M-9A0 (Calpella + N11P/M Discrete Graphic)

FOXCONN		HON HAI Precision Ind. Co., Ltd.	
		CCPBG - R&D Division	
Title ARD (CLK,MISC,JTAG)			
Size	Document Number	Rev	
Custom	M9A0 MP	1.1	
Date:	Thursday, November 19, 2009	Sheet	3 of 73

Title: **VGA (PCI-EXPRESS/STRAP) 2 OF 9**

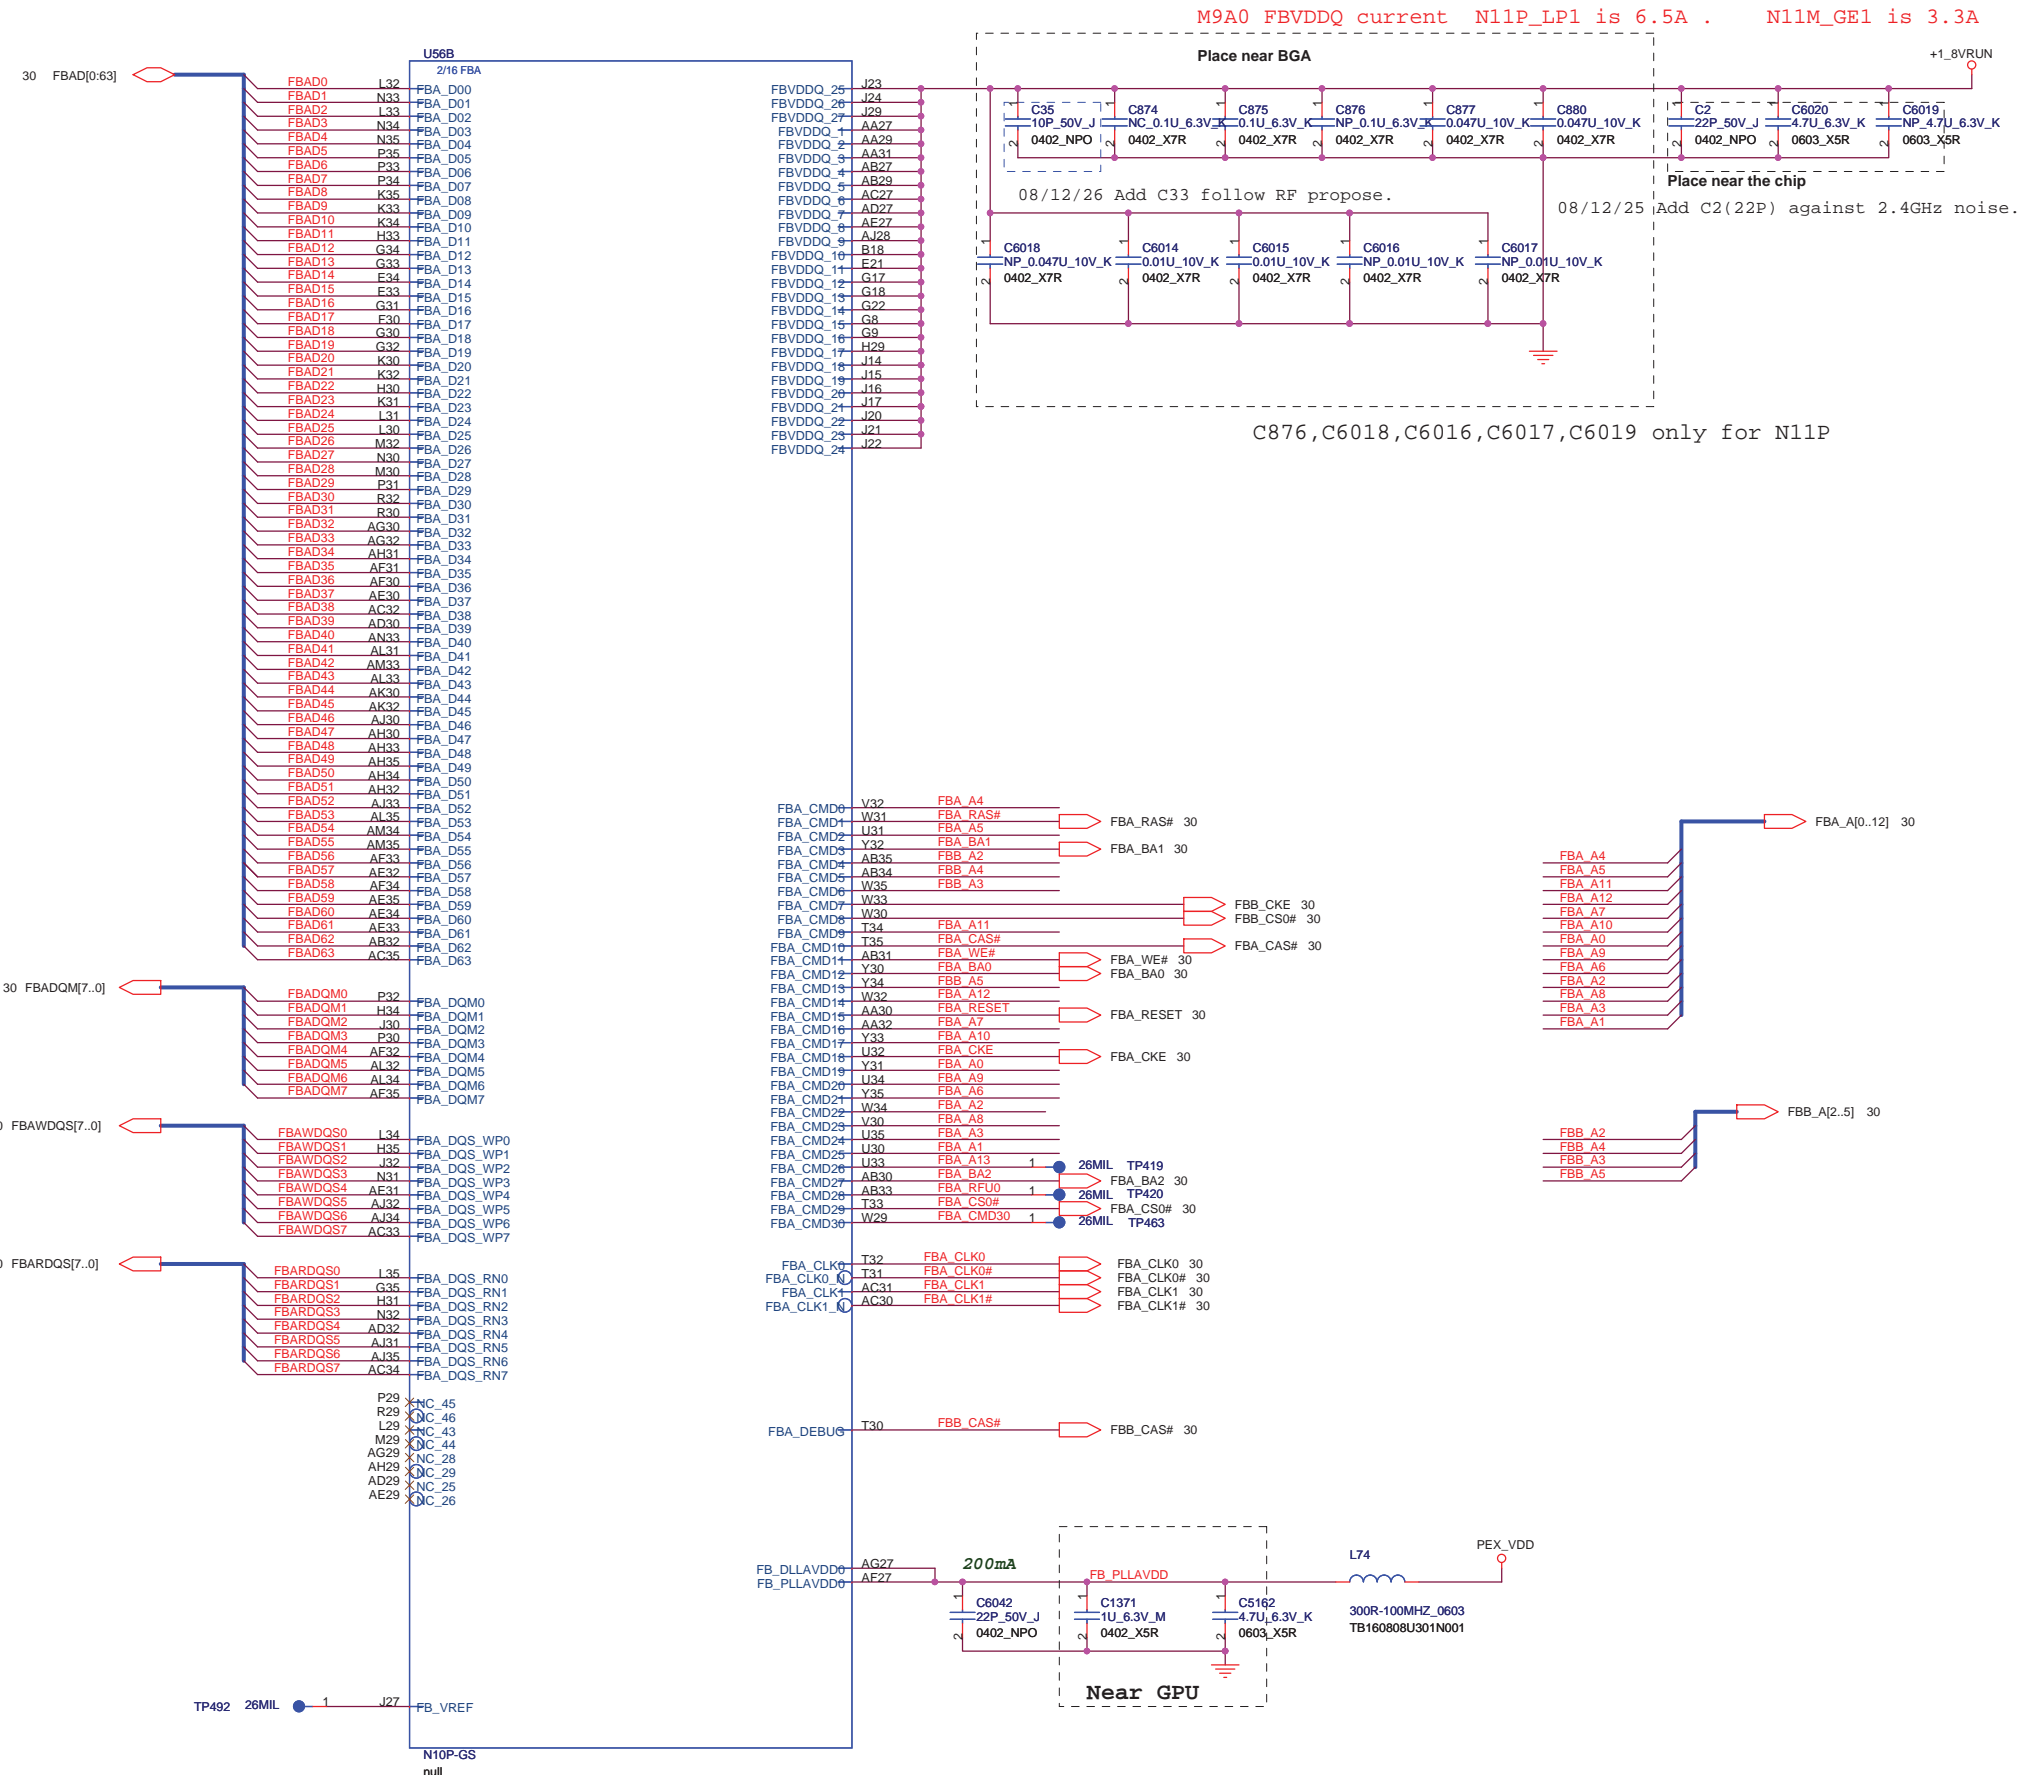
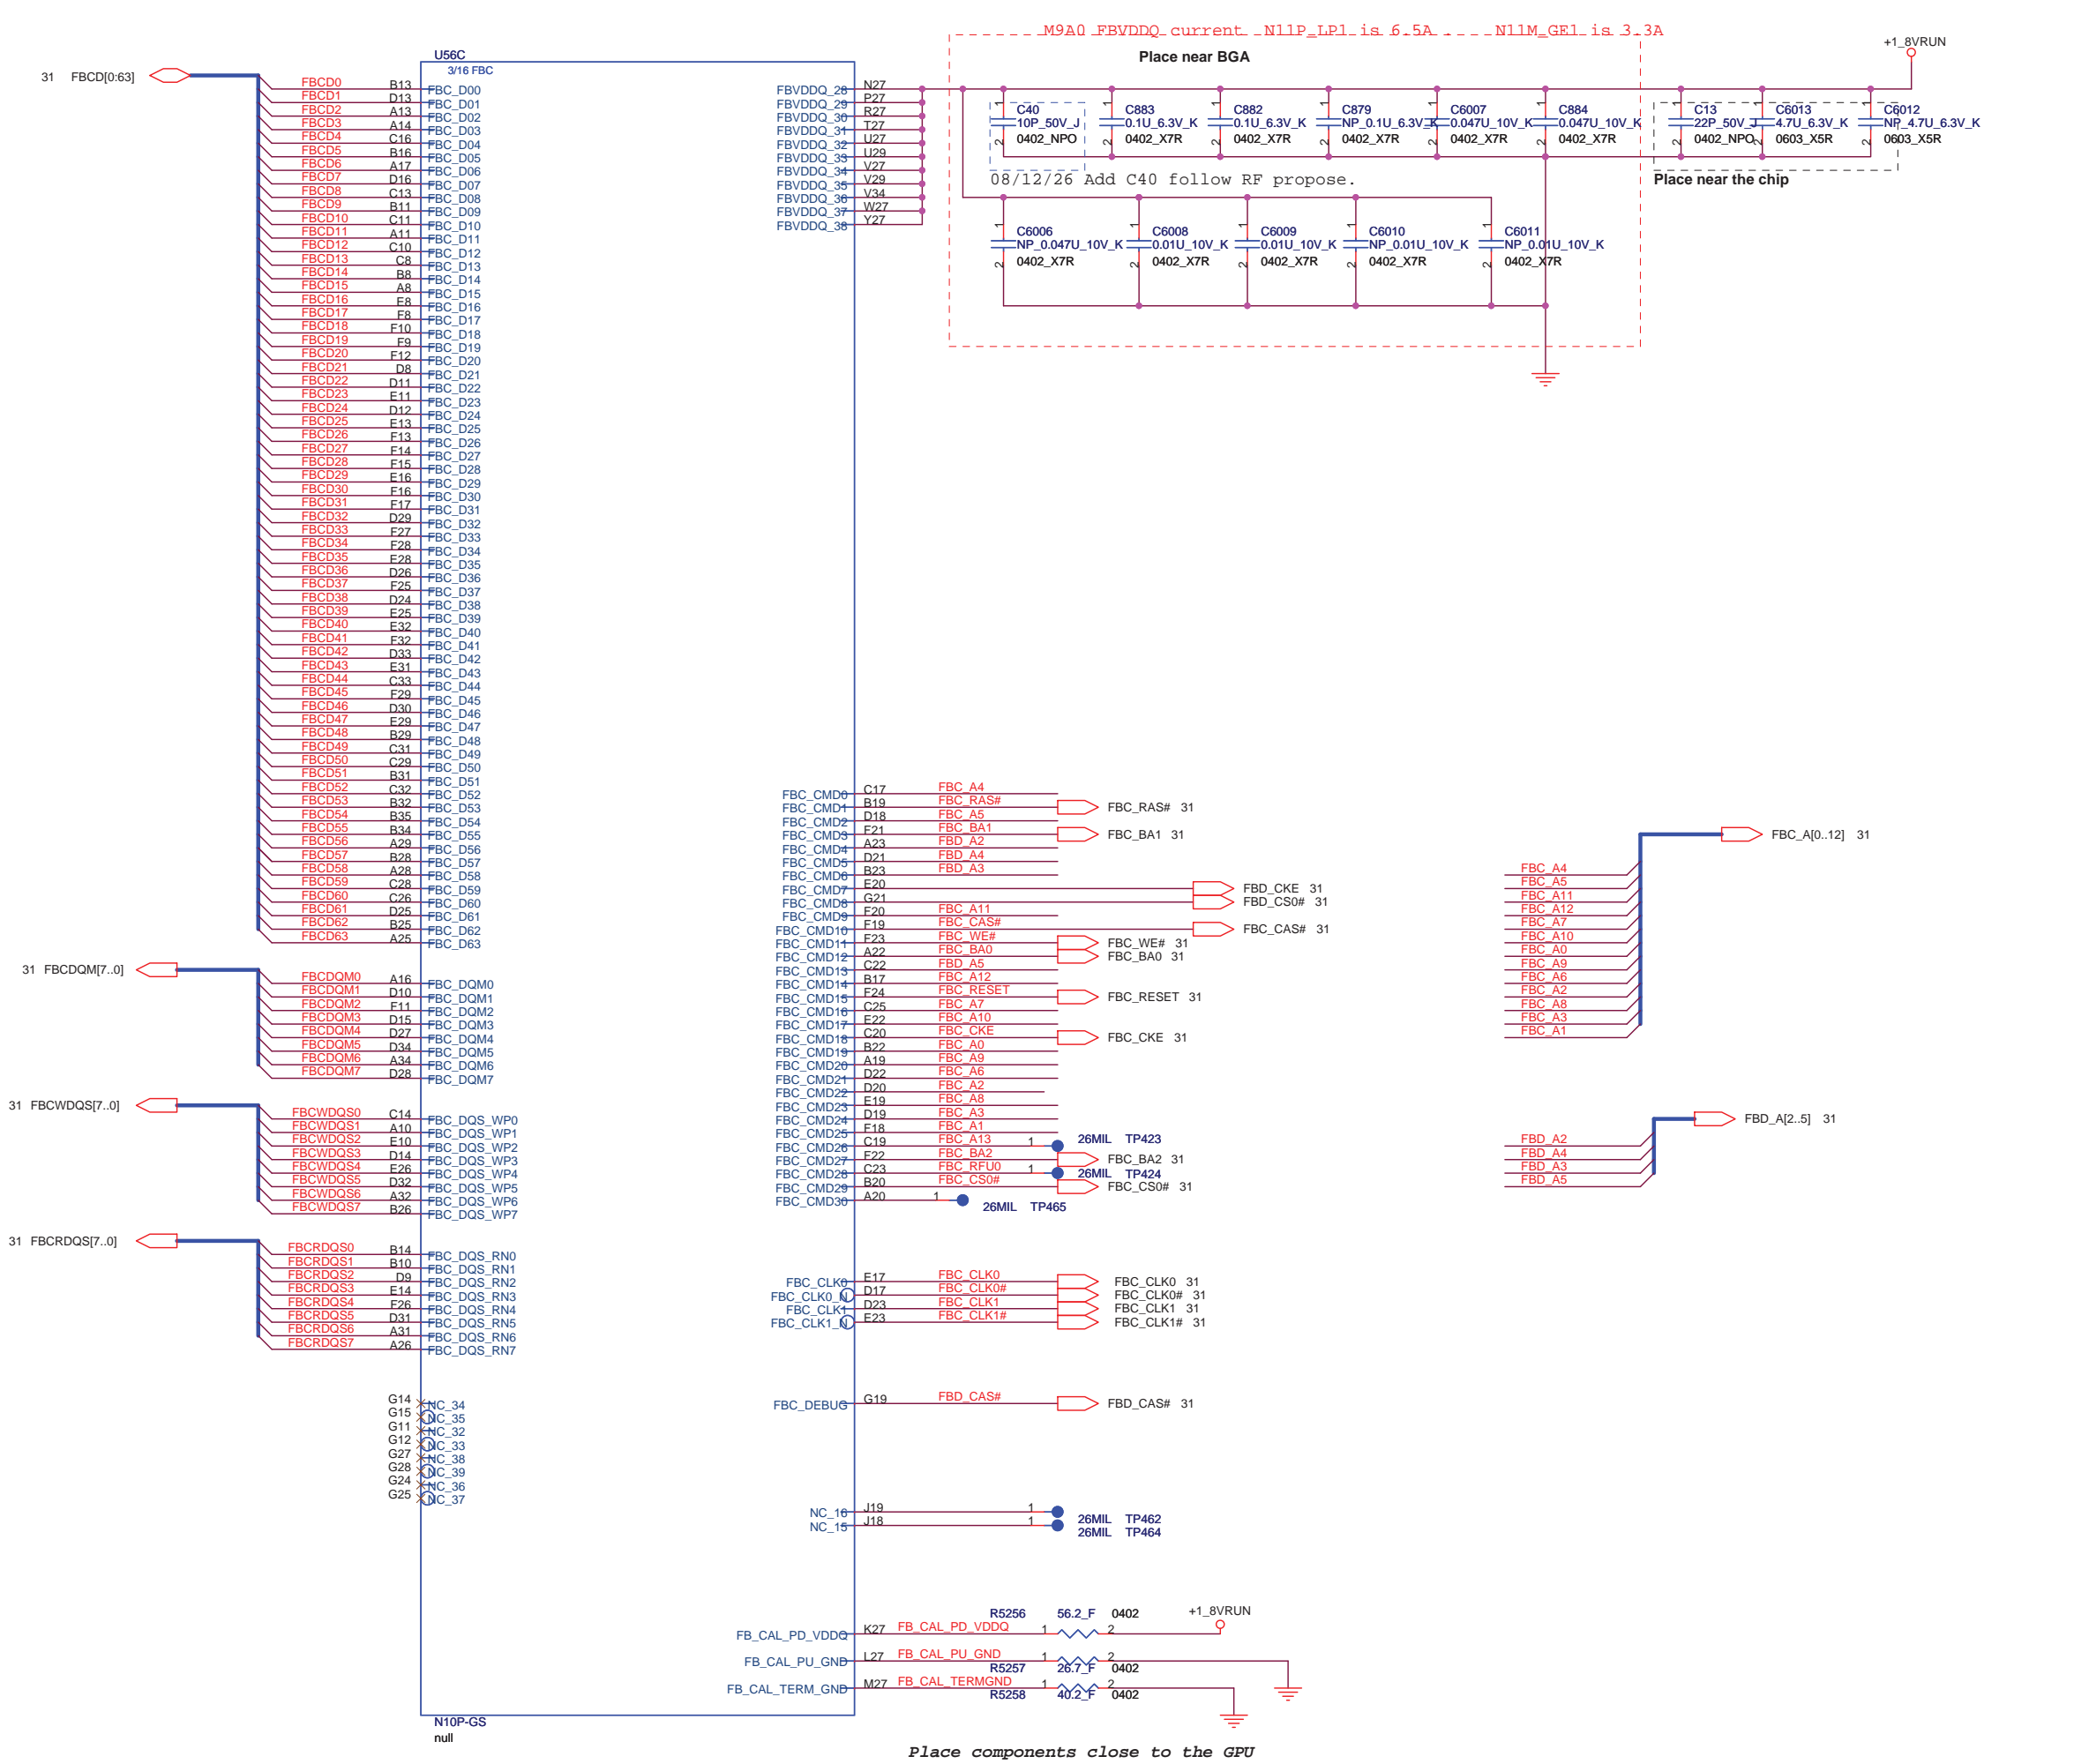
8/3 [DVT] Revise the Strap Pin value as FAE provided for DVT Sample.

2009/9/10
 N11P-LP1+SANSUNG(H2) SKU and N11M-GE1 +SANSUNG(M2 SKU) need change BOM
 R5244 change from 1R-0004532-F200(45.3K) to 1R-0002492-F200(24.9K) for nVIDIA FAE suggest

Title **VGA (LVDS/TMDS) 6/9**

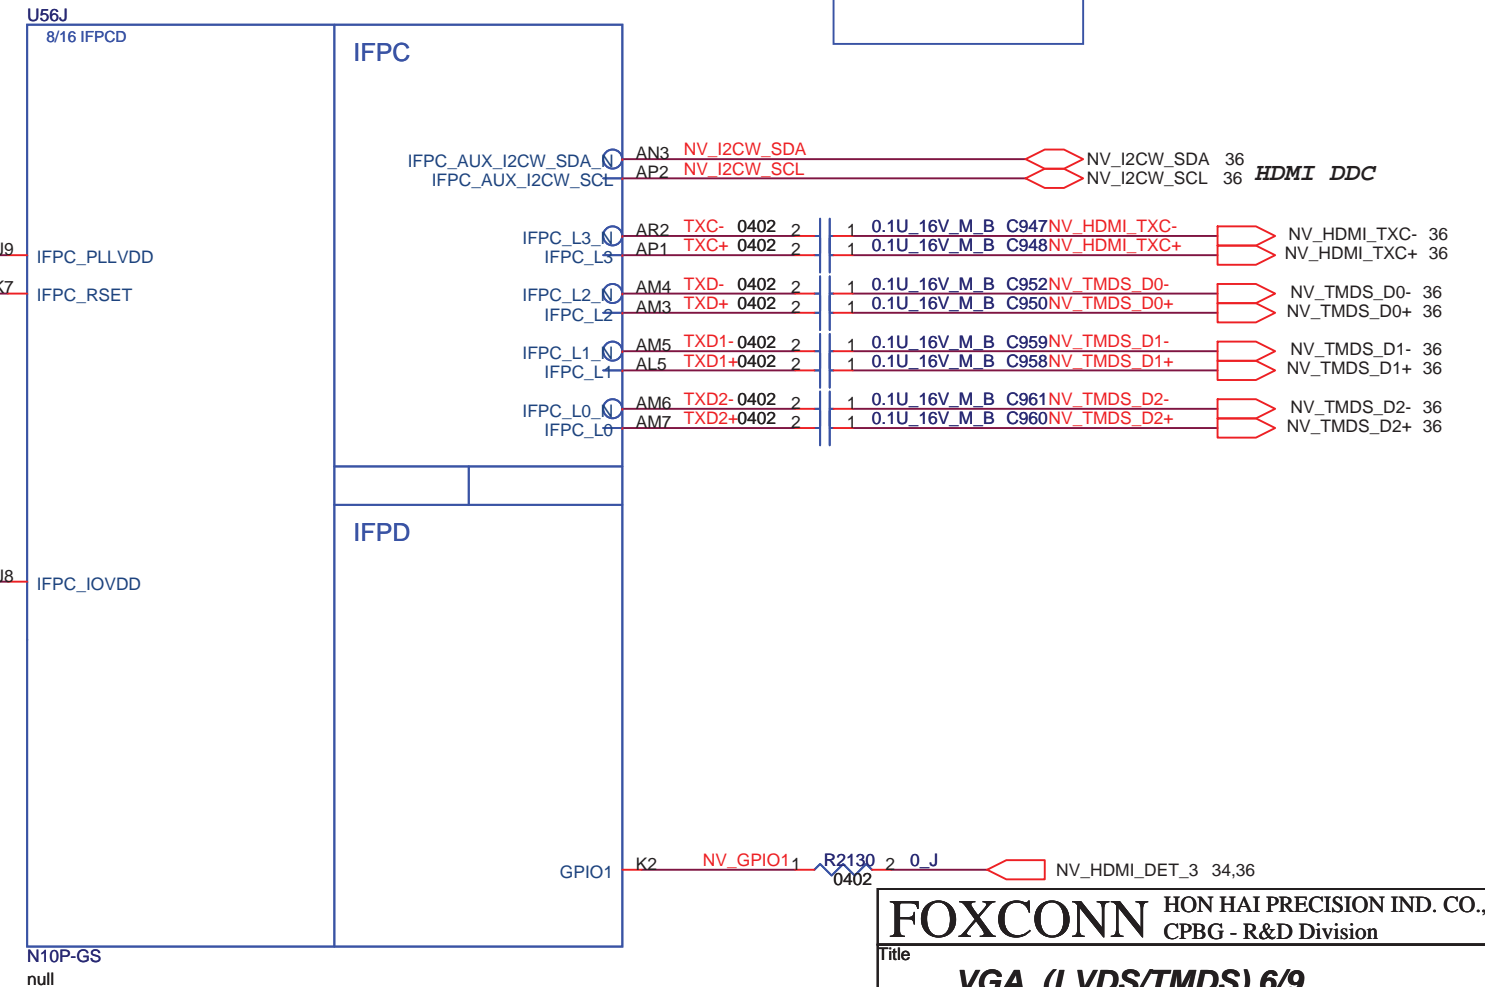
08/12/22 Change R1056,R1057 from 2.2K to 3.9K follow Mor-side propose.

2009.0921
change R5272,R5273 from NC to mount
